117. Visual Interaction Effect _ Icon

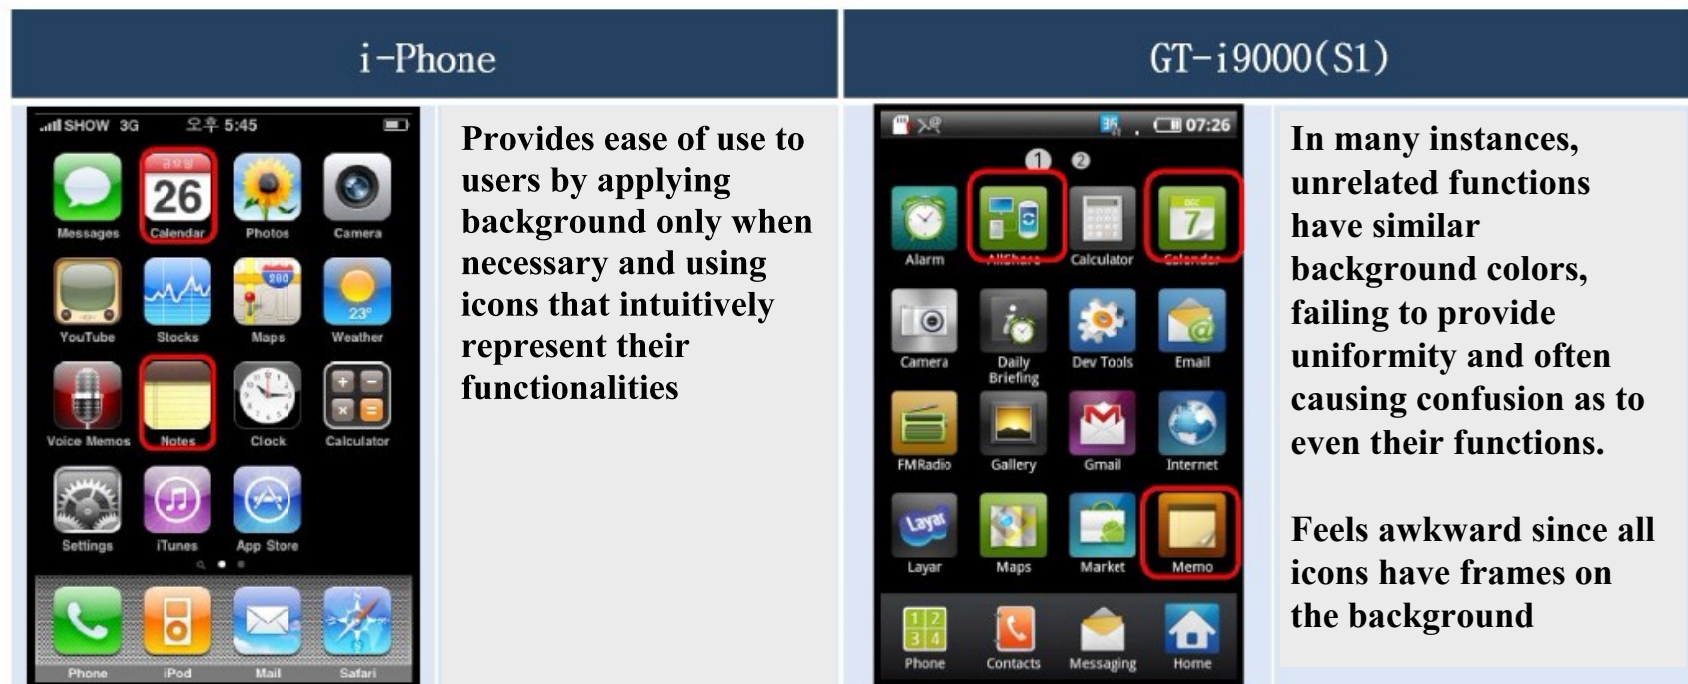
□ Poor color arrangement of rectangular frames on the homescreen that form the backgrounds for icons

- i-Phone : Icons on home screen have high intuitiveness because a background is used only when necessary
- S1 : Many instances where icons have similar background colors even though they do not have similar functions

Either change the colors of bordering rectangular frames according to a consistent pattern for a uniform feel, or remove the rectangular frame and use the icons only for a clean and uniform feel
